## Town of Franklin

### Planning Board

**May 4, 2020**

**Re: 12 Forge Parkway  
Site Plan Peer Review**

**EXISTING  
CONDITIONS PLAN**

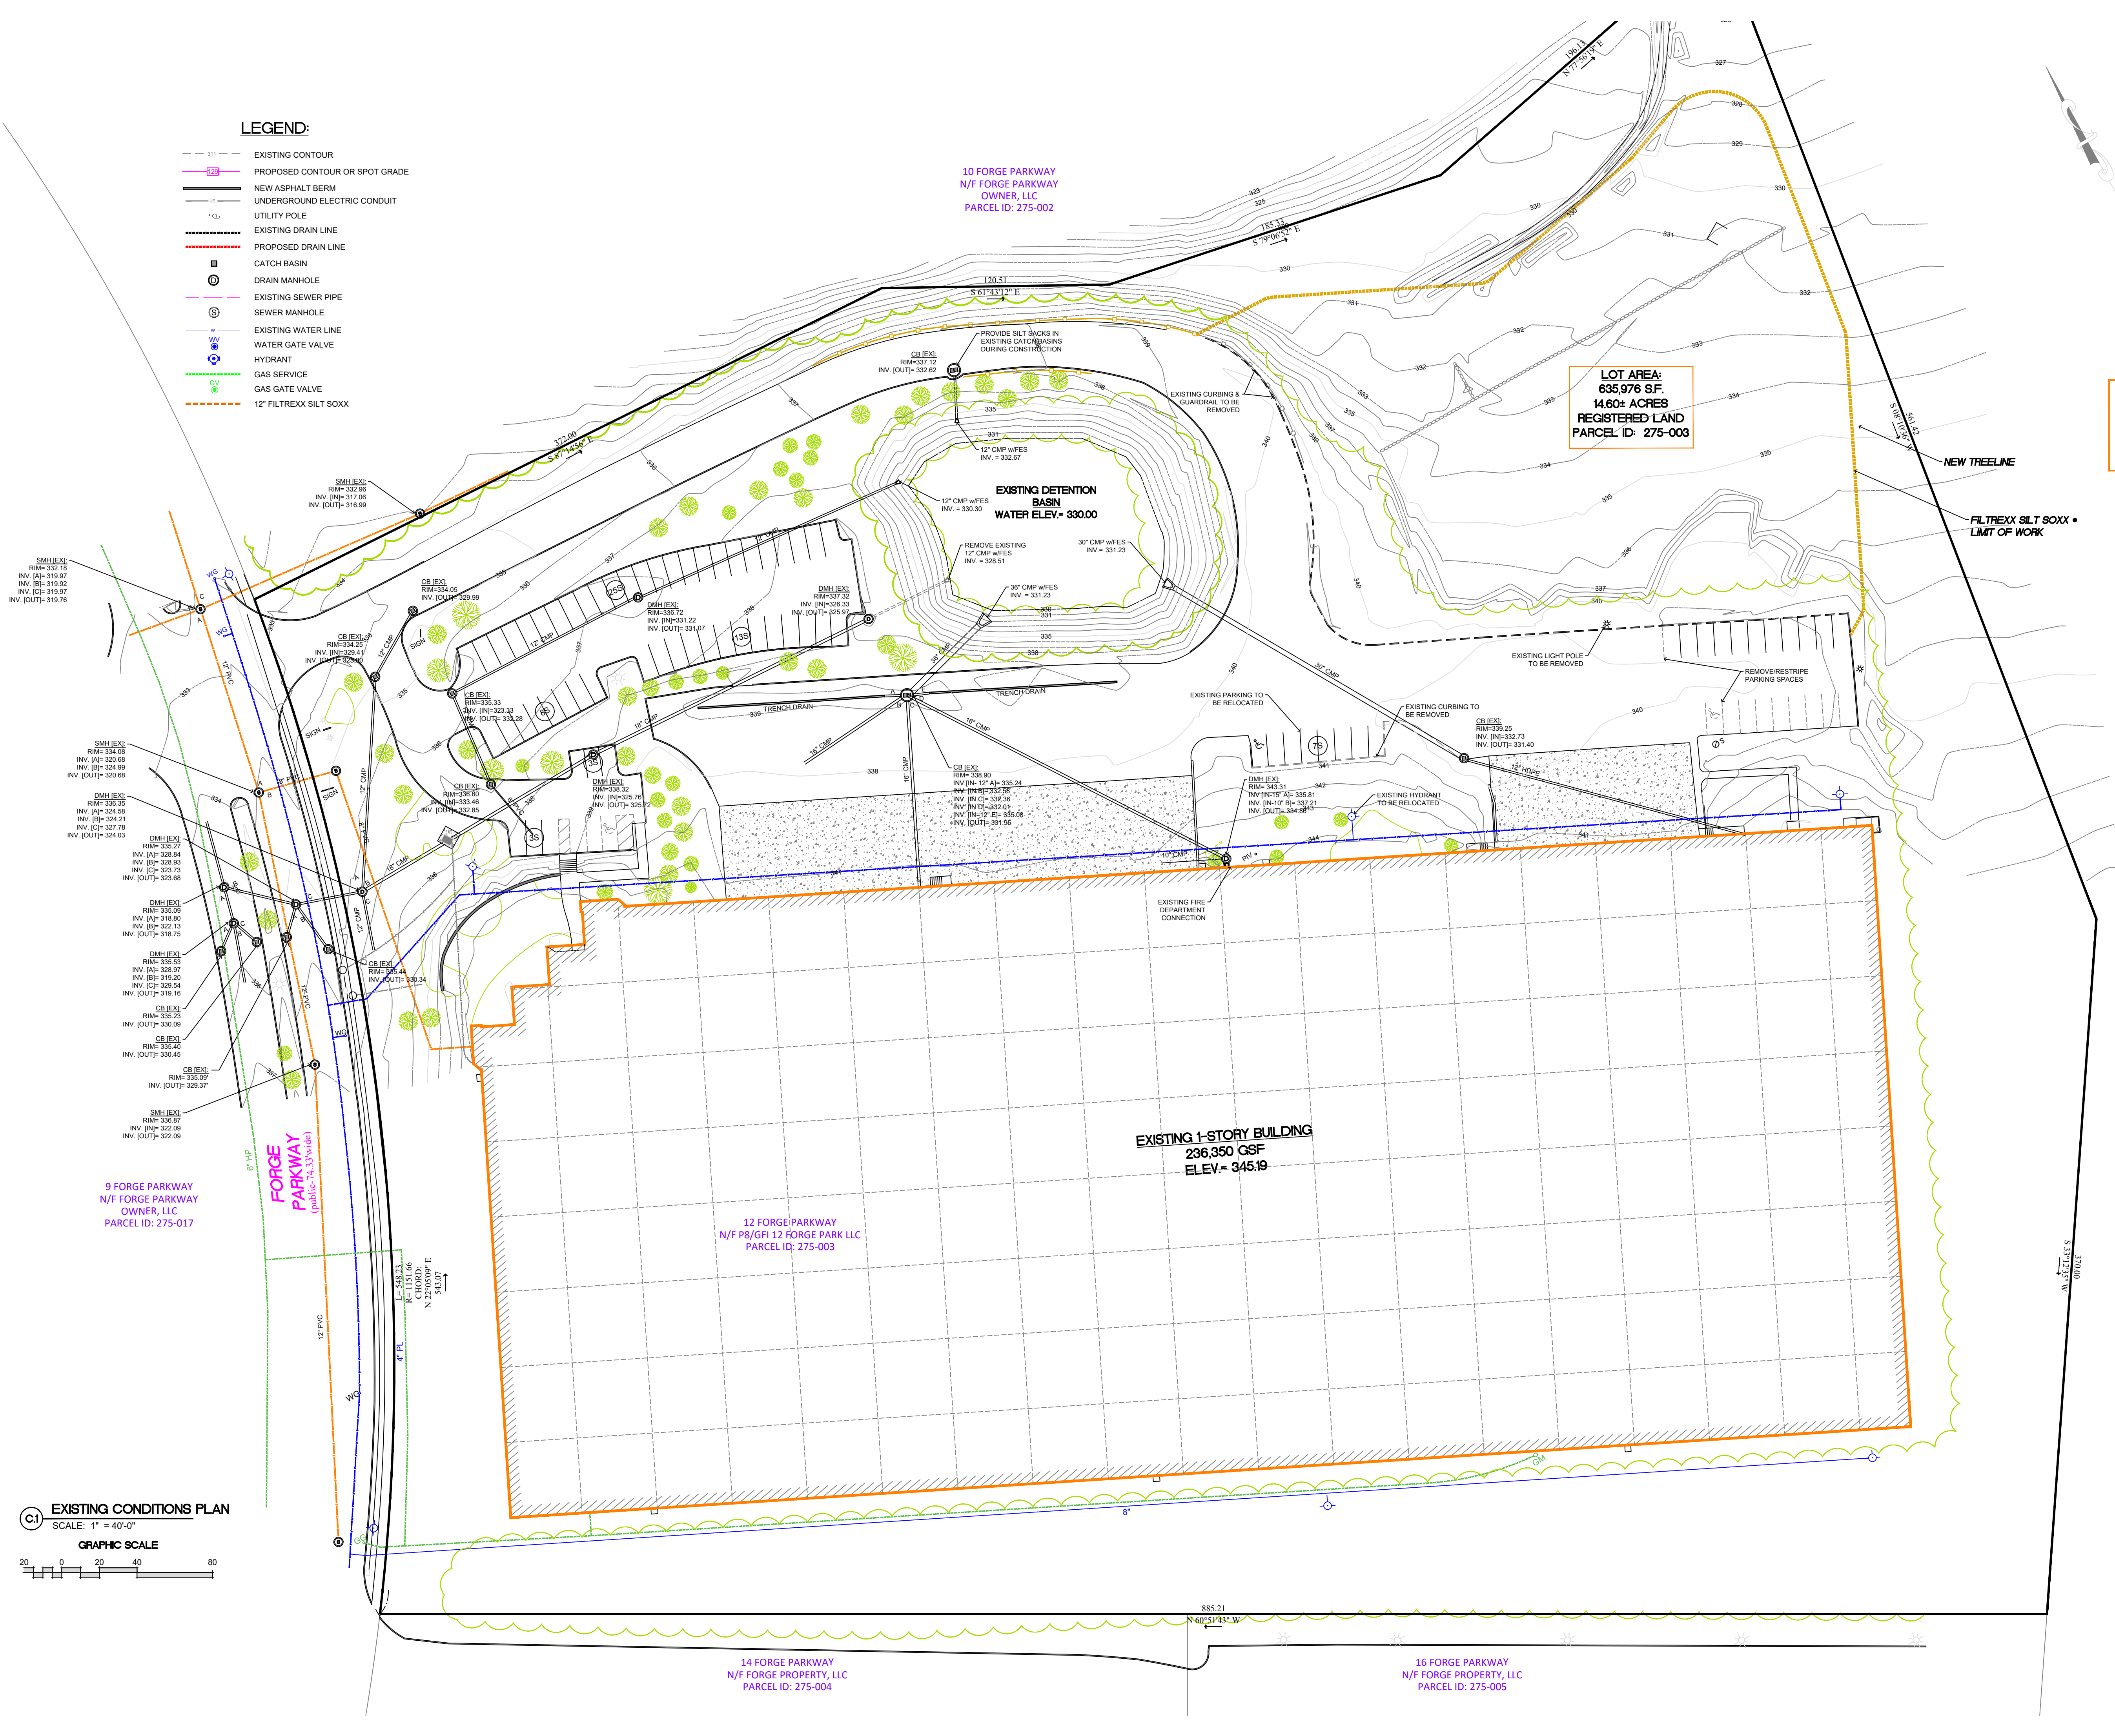
- G1. Revise existing conditions plan to remove proposed features such as erosion control barrier and restriped parking spaces.
- G2. Provide details for the proposed concrete pad, timber guardrail, and typical drainage pipe installation.
- G3. Resolve proposed pavement depth discrepancy between Site Plan Layout plan and Details.
- G4. Clarify if any pavement rehabilitation is proposed for the existing parking areas.

**C2 SITE LAYOUT PLAN**  
SCALE: 1" = 40'-0"

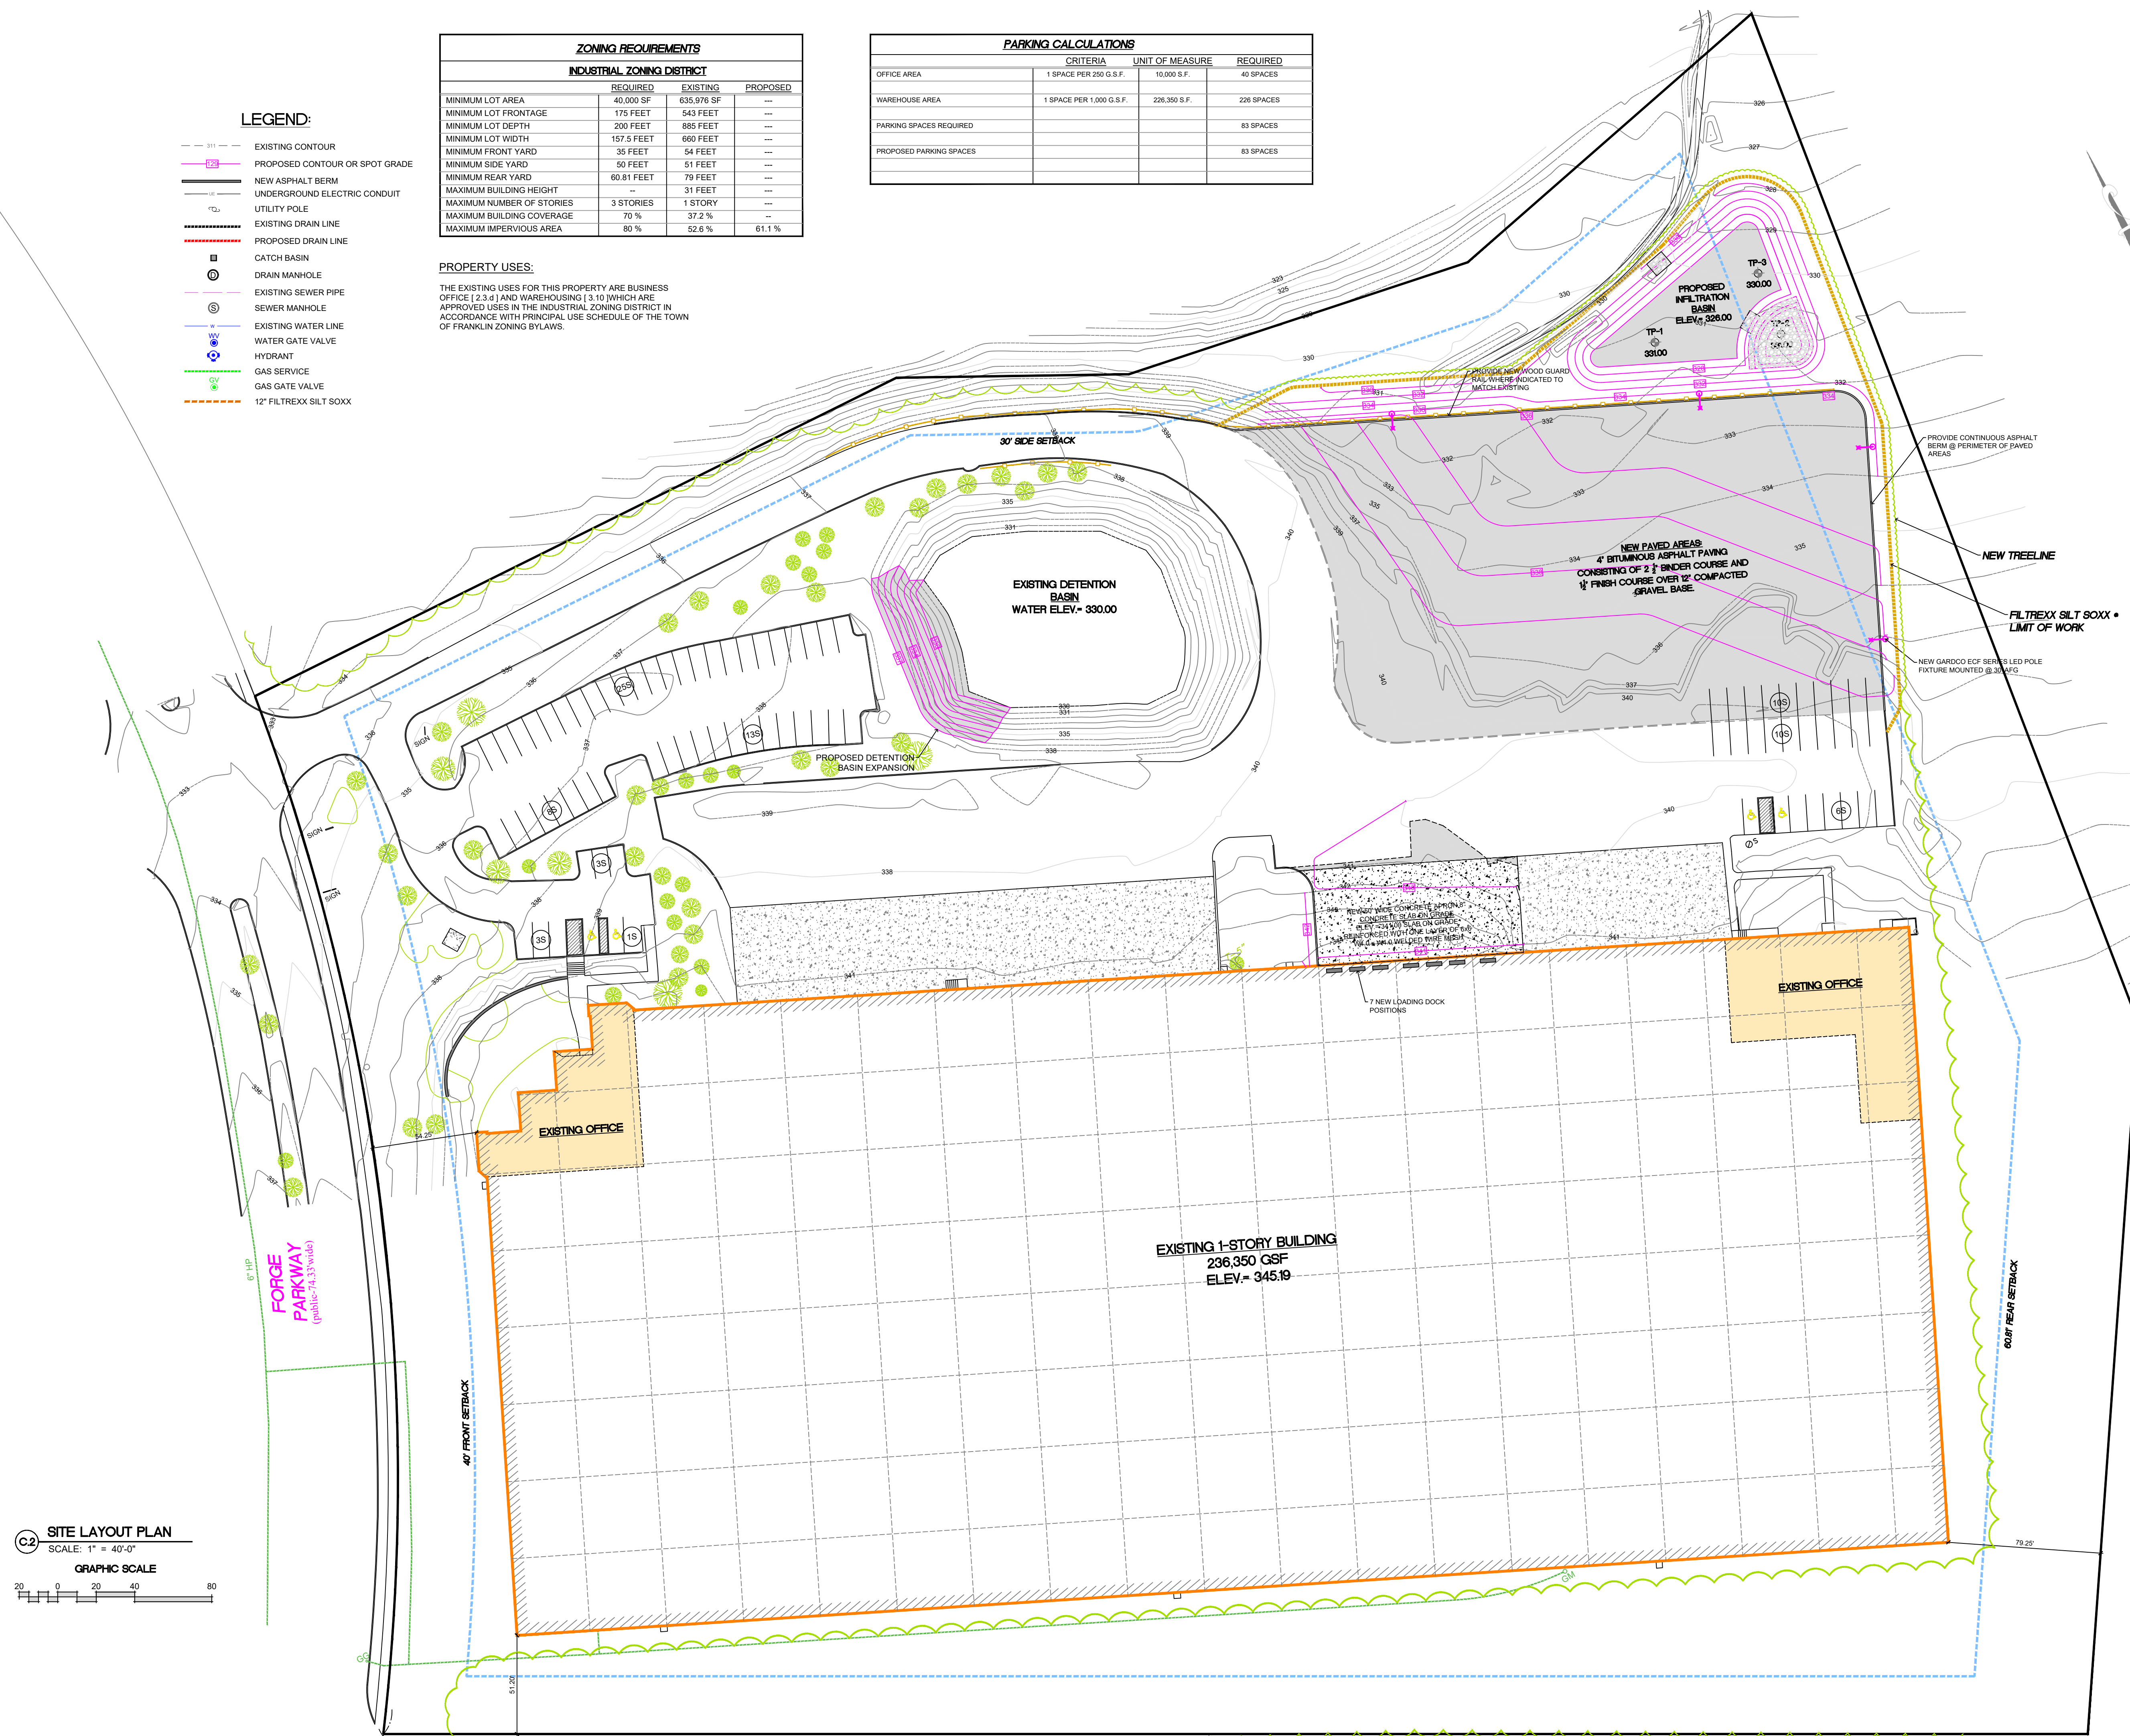
- P1. Provide typical dimensions for the proposed parking spaces.
- P2. Provide striping separating the 10 proposed parking spaces in the new pavement area from the 10 spaces in the existing pavement area. The plans appear to show 10 oversized parking spaces.

- P3. Revise parking number labels to match the number of existing/proposed spaces.
- P4. Confirm the total number of existing parking spaces. Based on the plans, it appears there are 82 existing spaces.

- P5. Revise the parking schedule to indicate the total number of spaces required per the calculations.
- P6. Clarify if any interior modifications or uses will affect the number of parking spaces used at the site. At the time of BETA's site walk, a portion of the building appears vacant.

- P7. Revise the parking aisle width at the northeast corner of the building to 24 feet (§185-21.C.(8)).
- P8. The project proposes to relocate an accessible space at the northwest corner of the building, which will result in a longer accessible route to the building than necessary. The two accessible spaces should be shifted to the east to minimize the accessible route path in accordance with MAAB regulations. Notwithstanding any site-specific need for a van accessible space at this location, the van accessible spaces proposed at the northeast corner of the building fulfill the number required by MAAB.

- C1. The Bylaw does not include any provisions for the installation of bituminous curb. At the discretion of the Board revise bituminous curb to be vertical granite or reinforced concrete curbing adjacent to parking areas.
